SACRAMENTO COMMUNITY CENTER AUTHORITY

MINUTES OF THE MEETING OF THE GOVERNING BOARD  
OF  
SACRAMENTO COMMUNITY CENTER AUTHORITY

That that certain document entitled "Addendum #2", dated June 10, 1971, which is the second addendum to the specifications for the construction of the Sacramento Community Center Complex, 13th and 14th, J and L Streets, Sacramento, California, is hereby approved.

ADDENDA  
DRAWING  
**13**

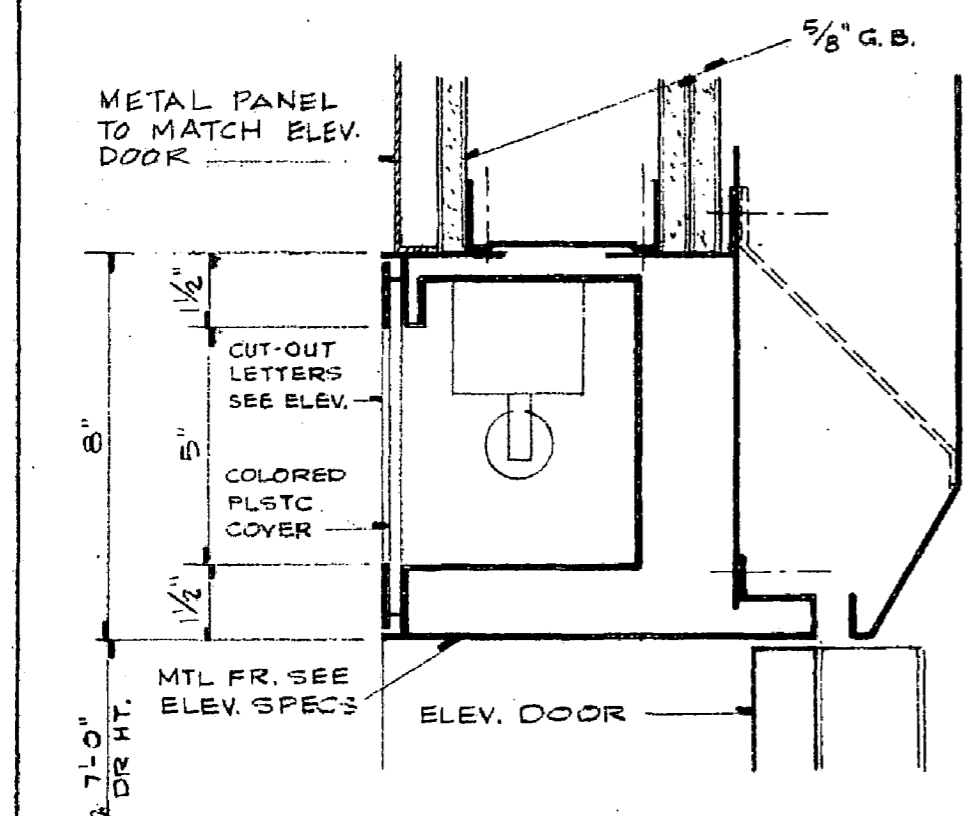
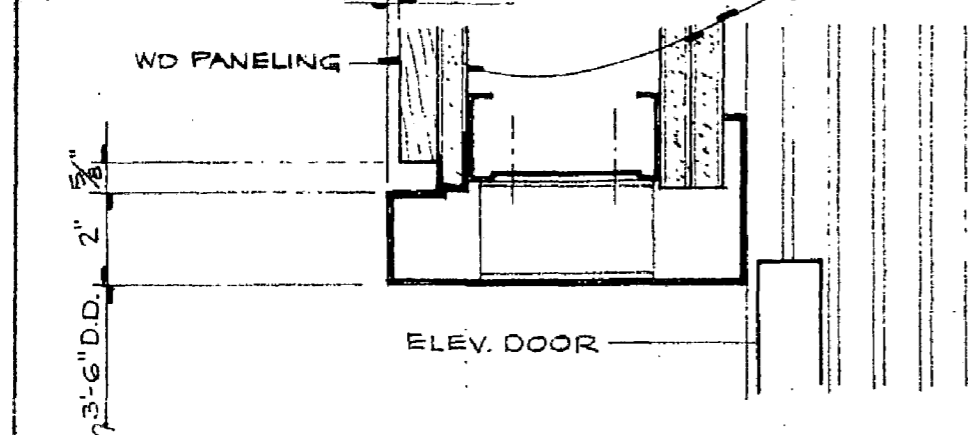
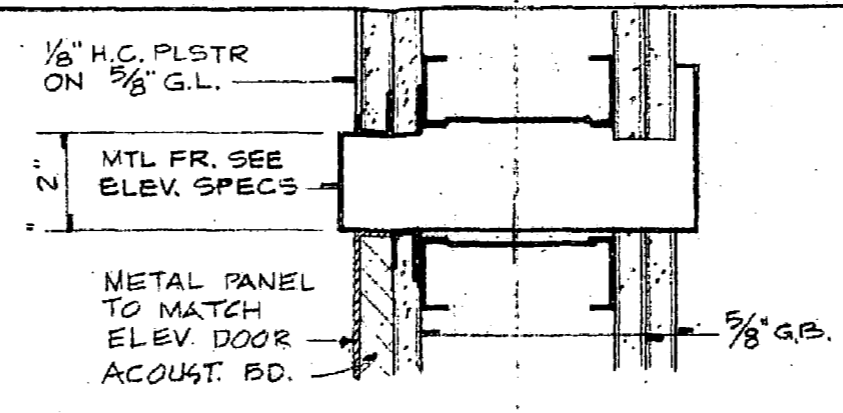
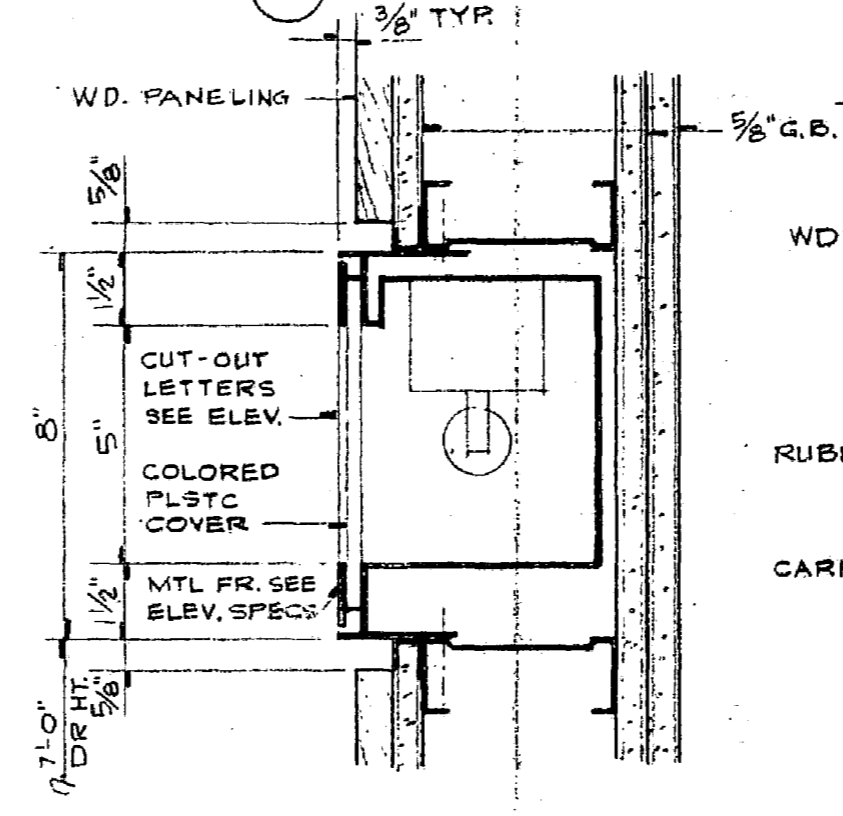
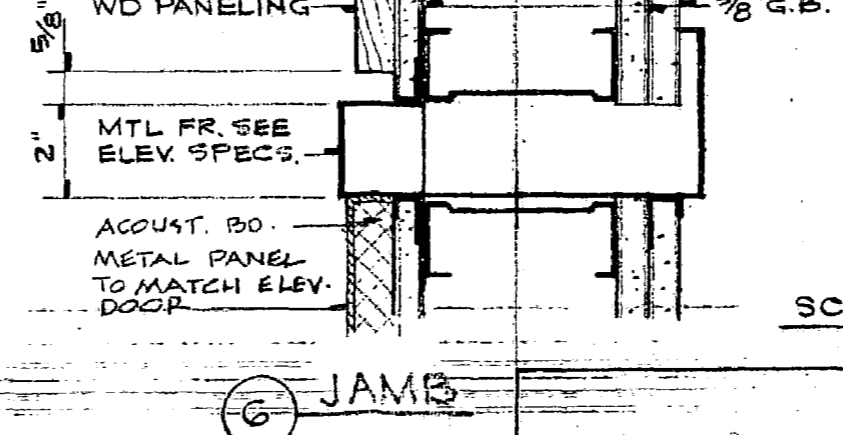
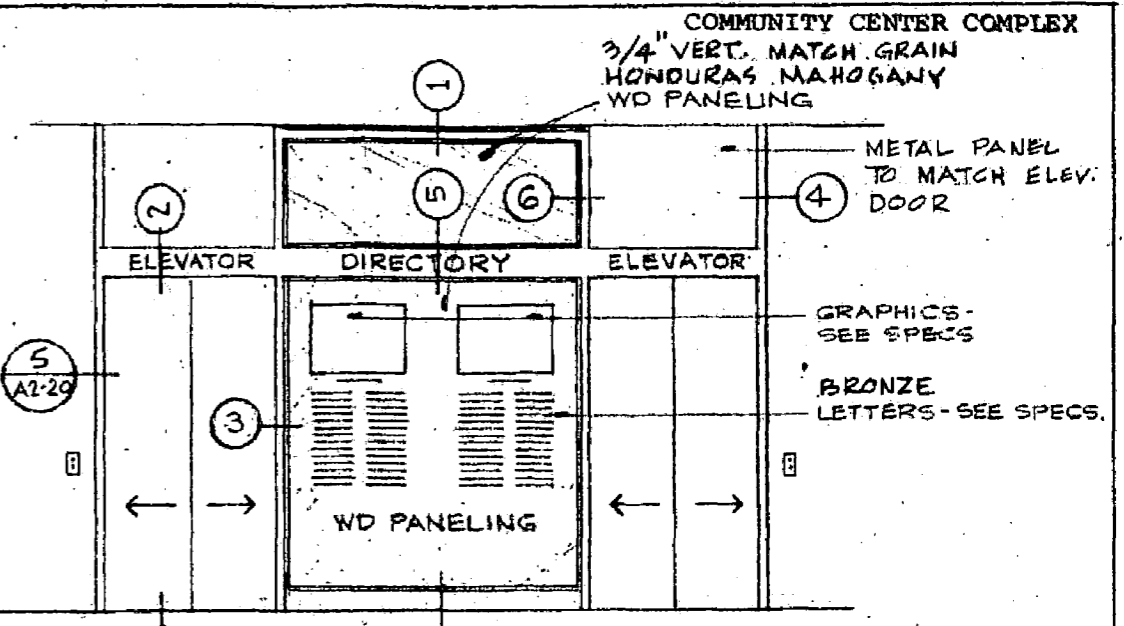
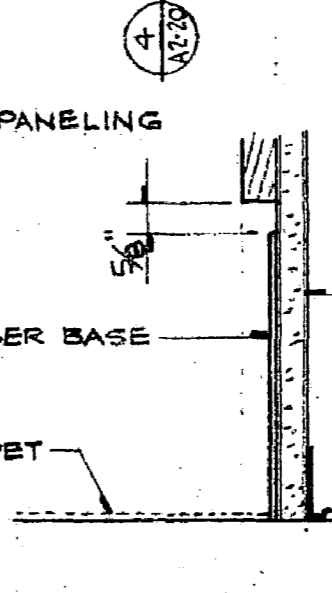
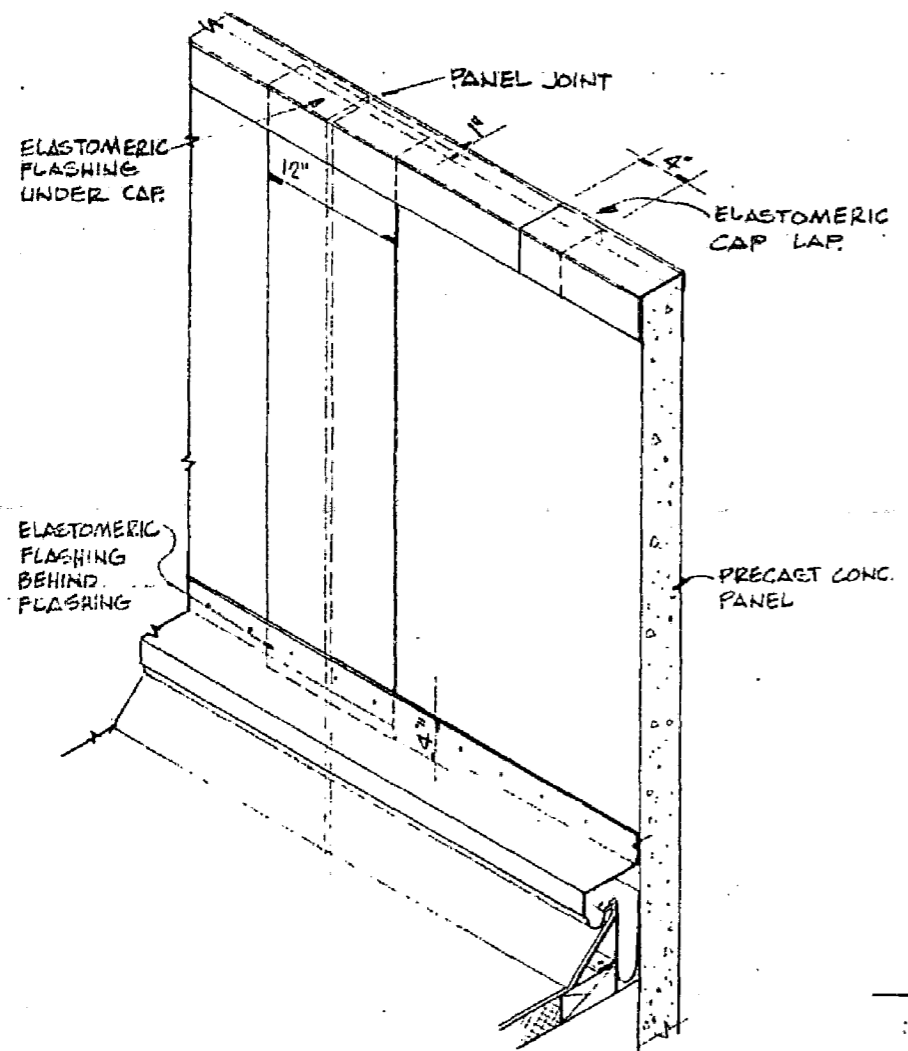
"Wood Paneling: As shown on Addenda Drawing #13."

ELEVATION - MOTOR CONTROL CENTER MCC-A1

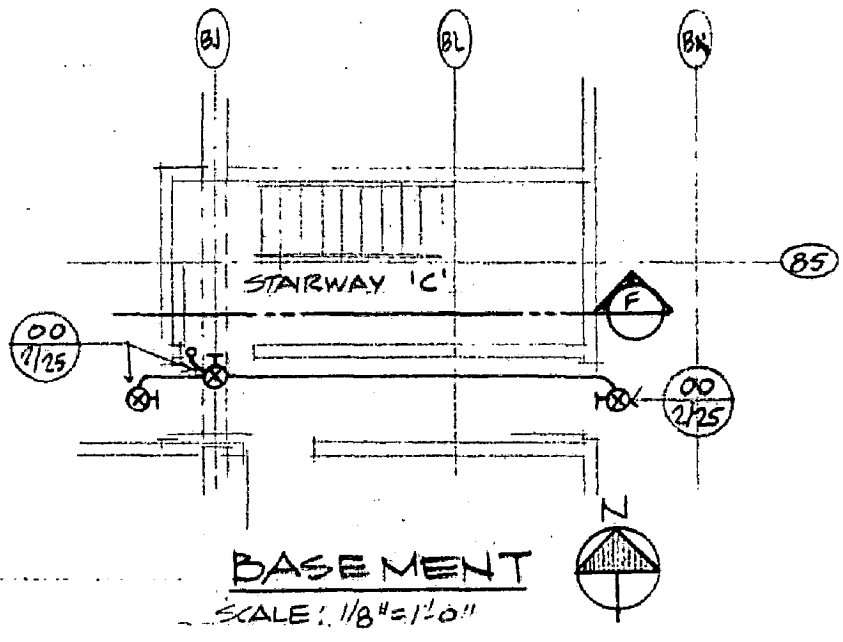
Delete elevation of MCC-A1 on Sheet EO-6. Replace elevation with Addenda Drawing No. 20

EXTERIOR STUD & PLASTER WALL  
AT P.C. CONC. PANEL - NORTH WALL MECH. RM 306  
 SCALE: 3" = 1'-0"

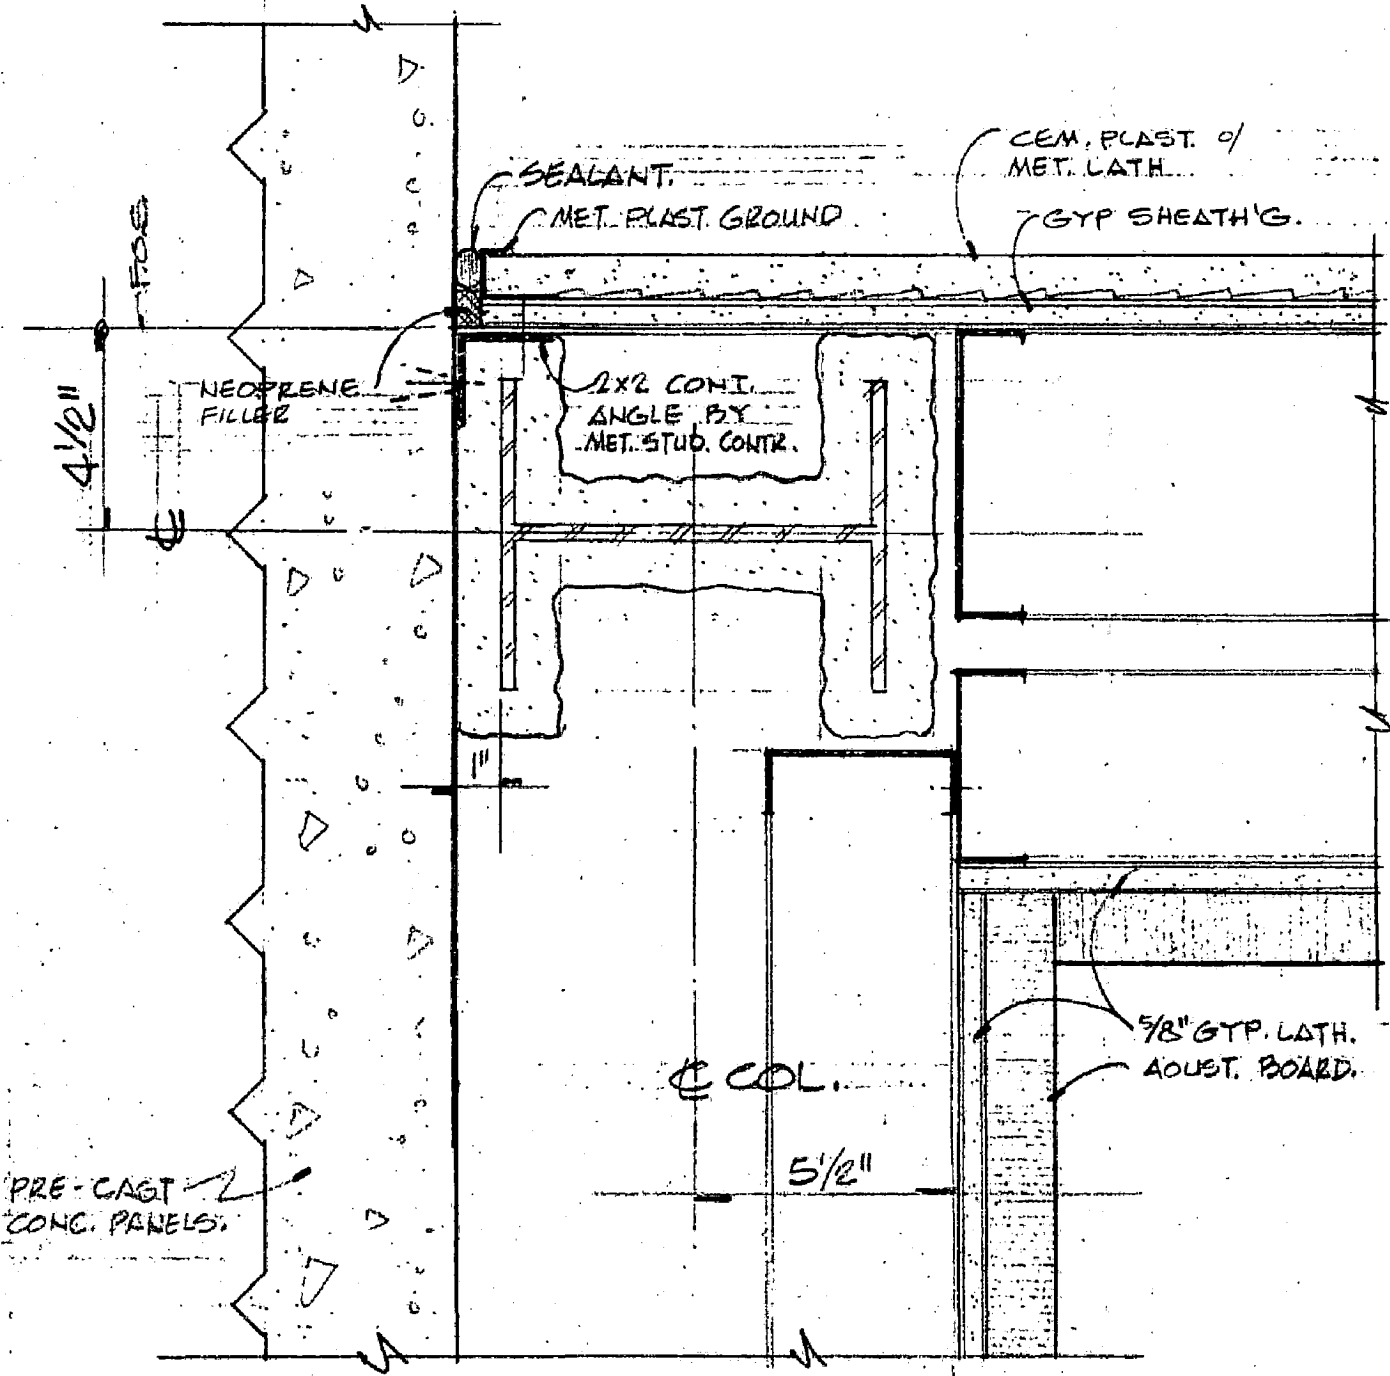
For detail of the cement plaster wall meeting the precast concrete  
panel at the north corner of Mechanical Room #306 see Addenda  
Drawing #22.

# Steel Pipe Pile

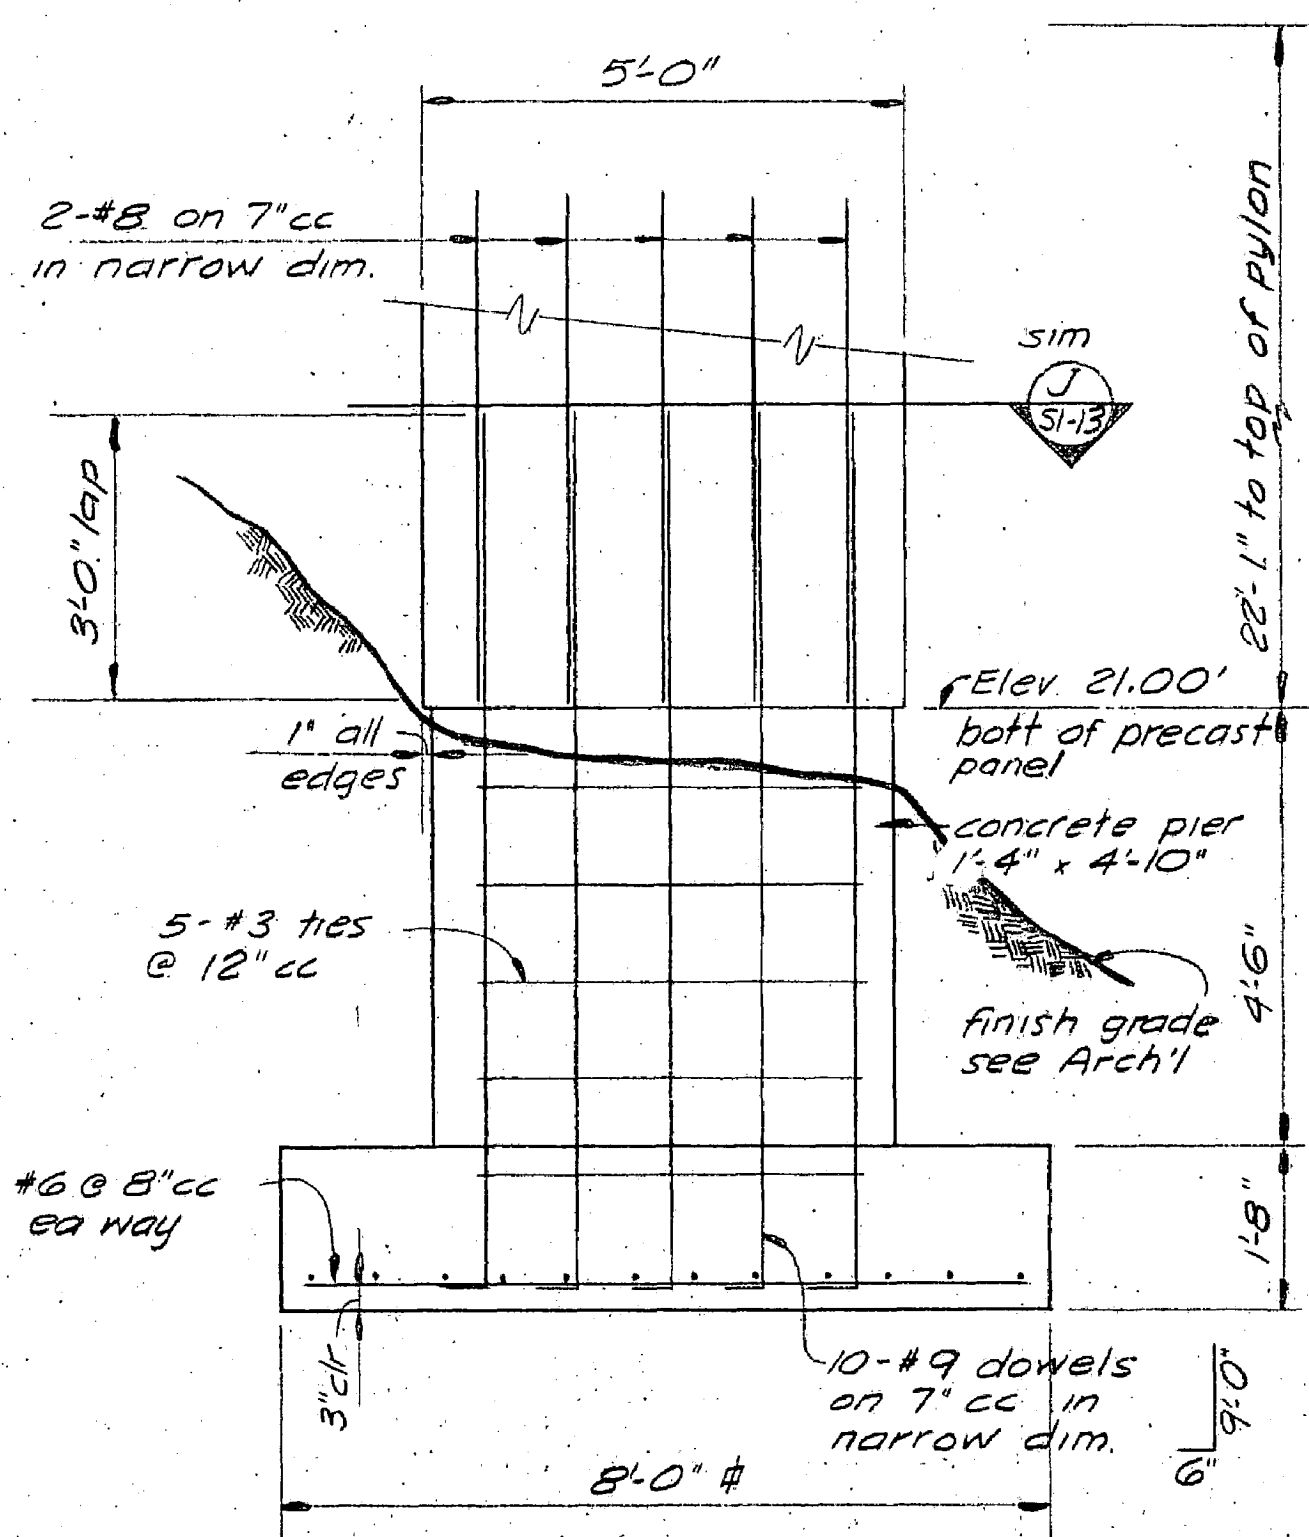
Addendum Drawing No. 24, shows alternate pipe piling detail.

ADDENDA  
 DRAWING  
**25**

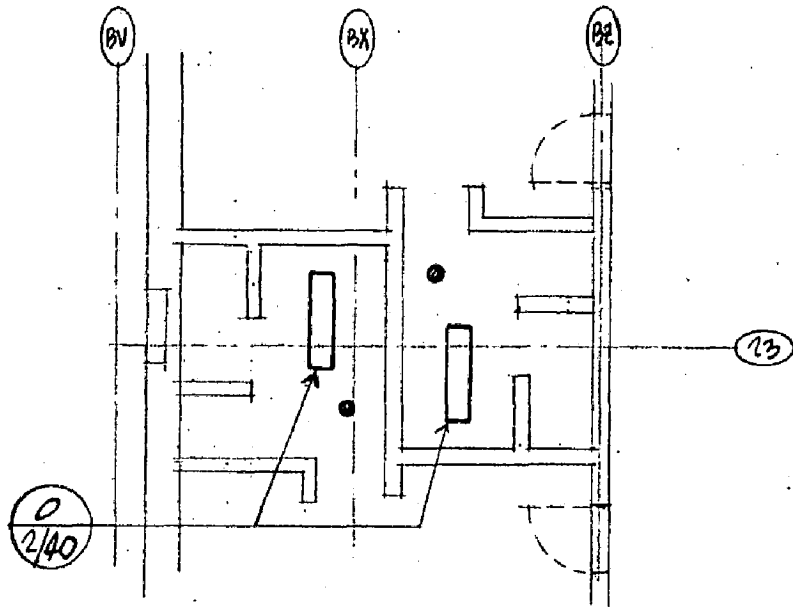
Seven pylons described in Item #17(b) shall be precast concrete pylons similar to Panel 1-18 Sheet AP-2 except without any notches. All flutes shall be continuous (no broken flutes), except with a smooth band at top and bottom as shown on Panel 1-18 Sheet AP-2. All pylons shall be complete with light fixtures. See Addenda Drawing #25 for elevation of pylons.
